Re: The Enclave at Lakeside (Amendment)

MDP # 795-A

**REVISED
 MASTER
 DEVELOPMENT PLAN**

**THE ENCLAVE AT LAKESIDE
 MASTER DEVELOPMENT PLAN
 PLAN # 795A
 DATE 09/17/04
 REV. DATE 04/18/07**

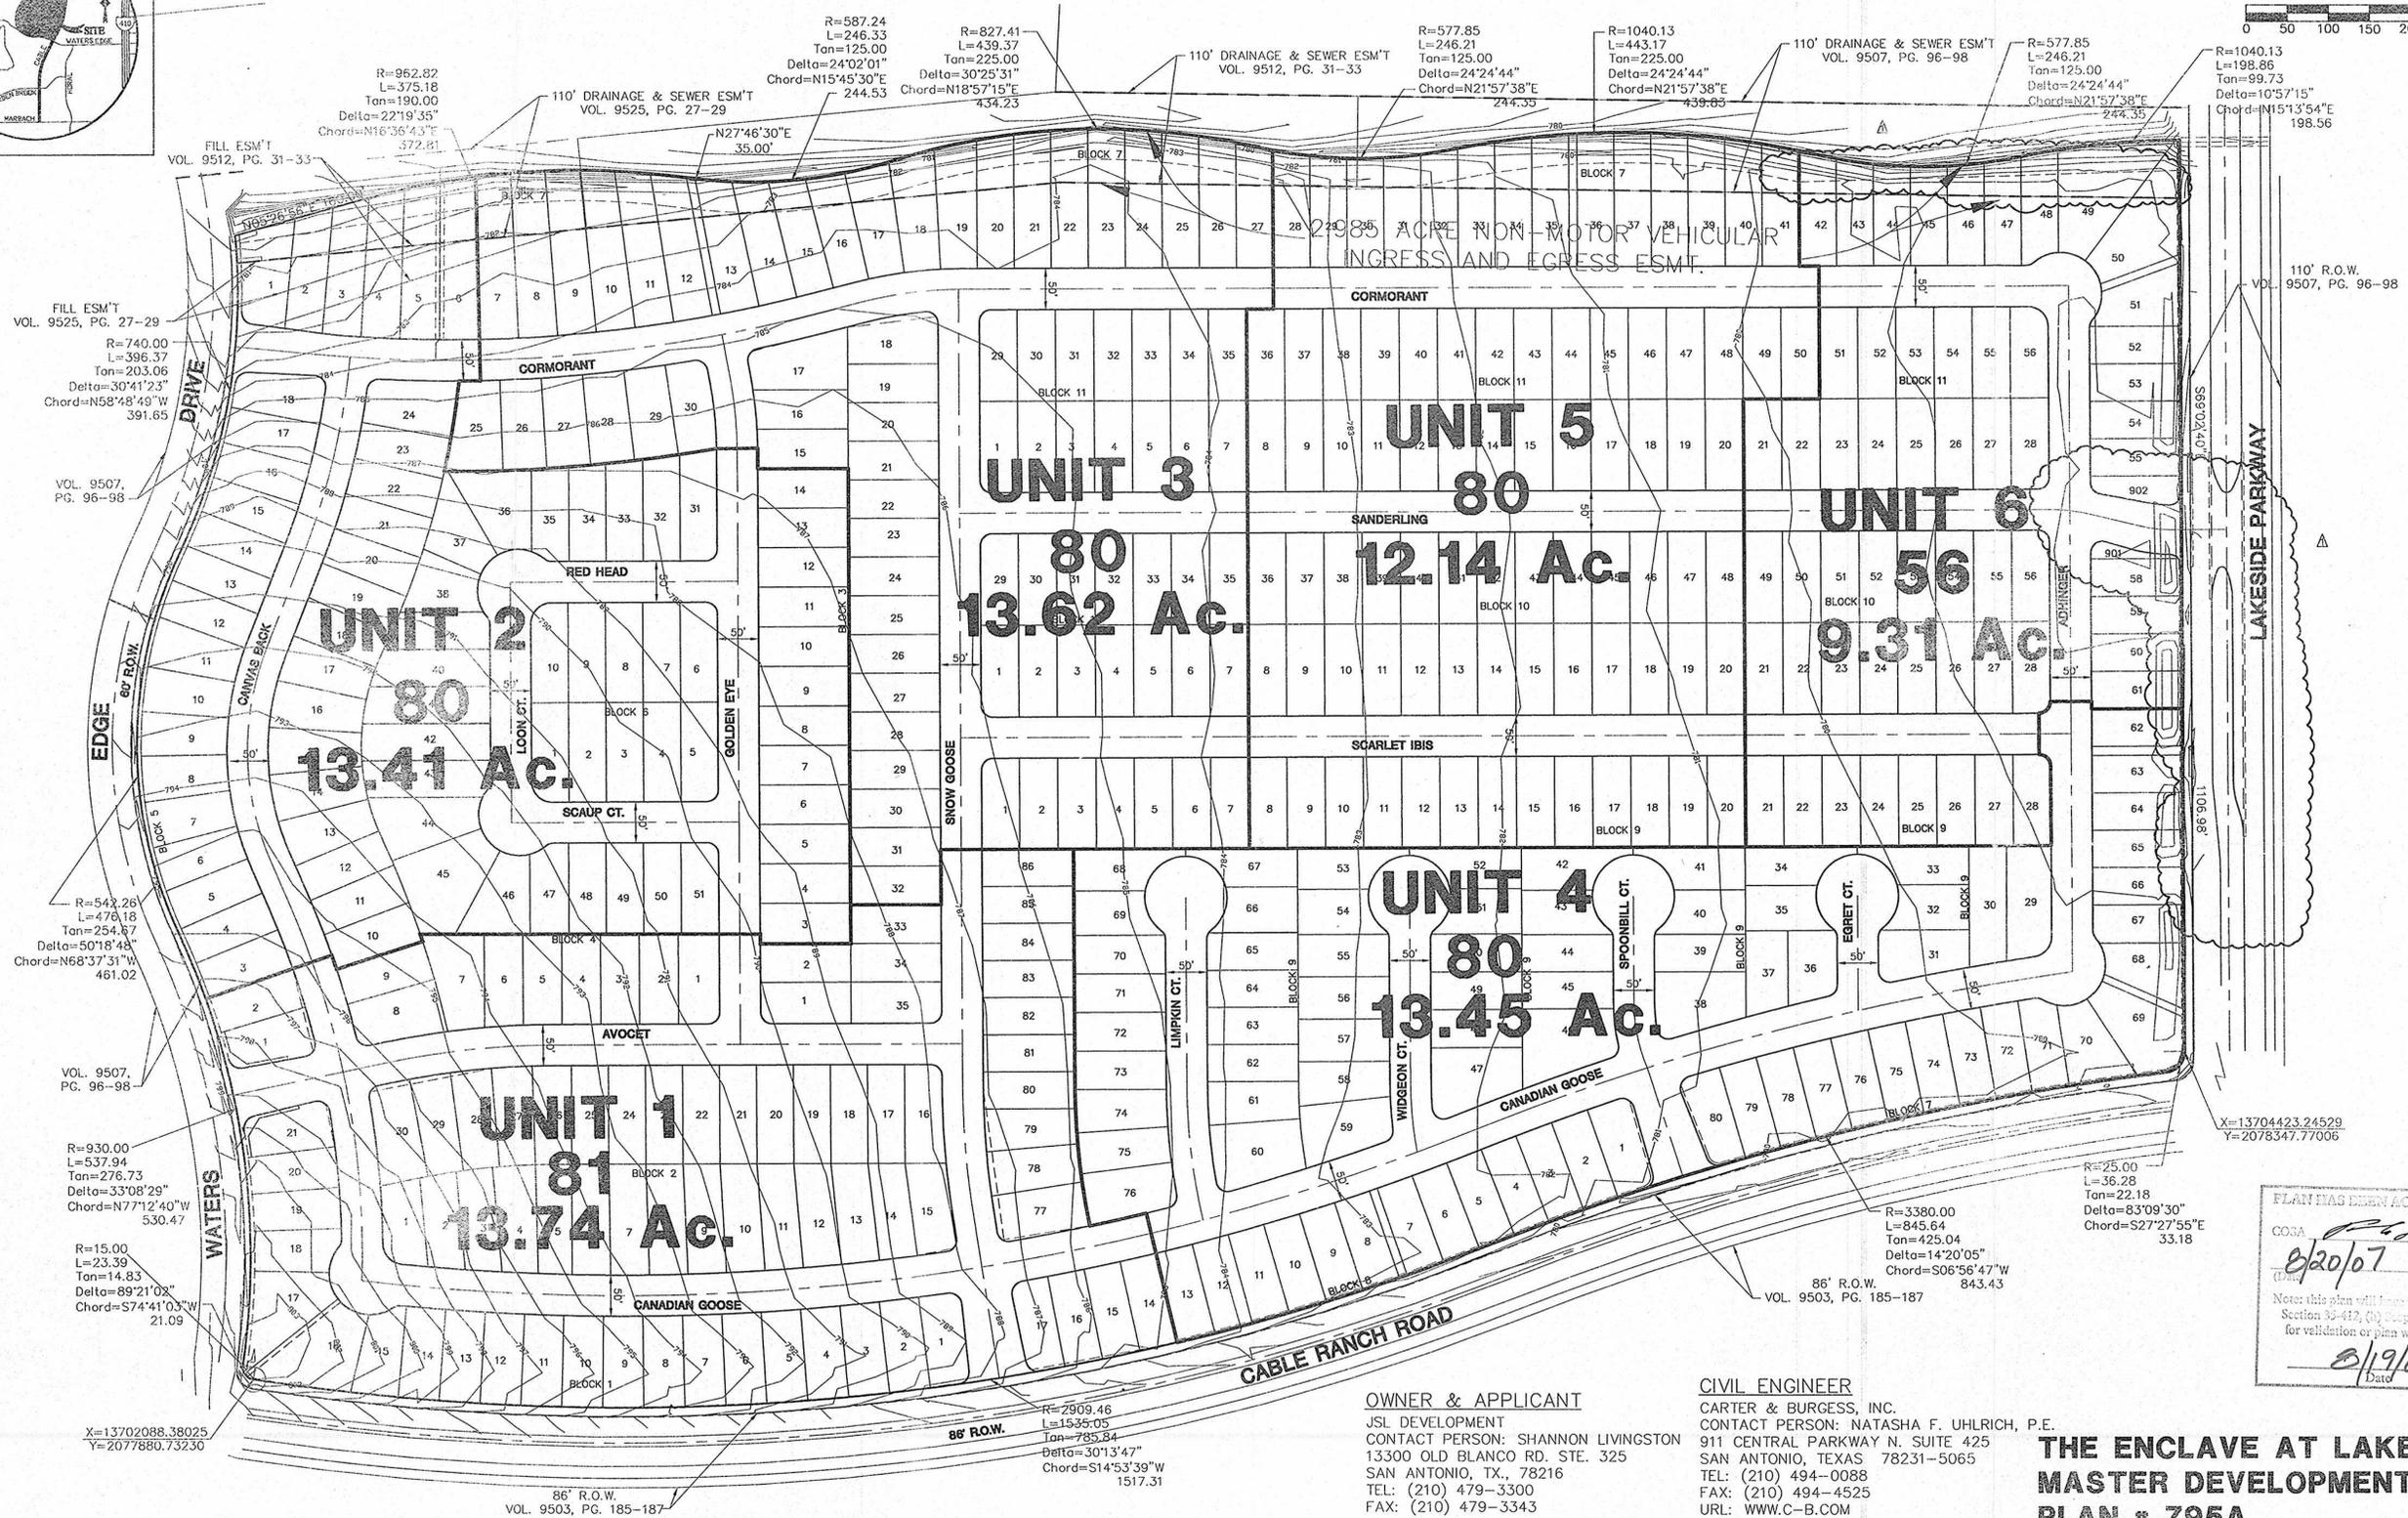
In consideration of public safety and convenience, excessive grades by reason of topography should be avoided in street layouts and arrangements. Any access and R.O.W. issues along state facilities will need to be resolved with the **Texas Department of Transportation (TXDOT)**. For information about these requirements you can contact TXDOT at 615-5814.

Revisions consist of addition of an entrance into the subdivision from Lakeside Parkway approximately 650' west of the intersection of Lakeside Pkwy and Cable Ranch Road. The result of this revision is a decrease of two subdivision lots and a decrease of two peak hour trips.

- All access roadways shall provide clear sight distance along Lakeside Parkway to provide adequate obstruction-free viewing distances for approaching traffic. All signage, landscaping, and improvements shall be selected and located so as not to block these clear sight distance areas.
- All roadways shall follow UDC 35-506 Transportation and Street Design and shall comply with UDC 35-502.

It should be understood that this is a general review of a conceptual plan not an in-depth review of internal and external traffic flow, nor streets and drainage plans. The internal street network shall be planned in order to provide safe and efficient movement of traffic to and from, within and past, the proposed development, while minimizing the impact to non-site trips.

The Enclave at Lakeside is a proposed subdivision with 457 single-family residential units. UDC Section 35-503, Table 503-1 of the 2004 Unified Development Code states that single-family development is required to provide 1 acre of park/open space per every 114 dwelling units. The requirement for this development is 4.0 acres. This MDP provides parkland dedication pursuant to UDC Section 35-503 (b)(6) in which parkland is provided by the adjacent Lakeview PUD. The dedicated park acreage within this Planned Unit Development was platted with Plat #050165, Lakeside Unit 1, and totals 19.6 acres of existing parkland dedication.

Tree Preservation approves with the following conditions: The Master Development Plan meets the criteria of the 2003 Tree Preservation ordinance (section 35-B125 and Table 35-B101).

- The project will be subject to the streetscape standards and 2003 Tree Preservation ordinance.

All platting shall comply with the Unified Development Code, Master Plan, and Major Thoroughfare Plan for the City of San Antonio. It will be expected that all of the property depicted in your Master Development Plan to include floodplains, drainage areas, and open space shall be platted. If the proposed development is not platted in phases this Master Development Plan shall become invalid.
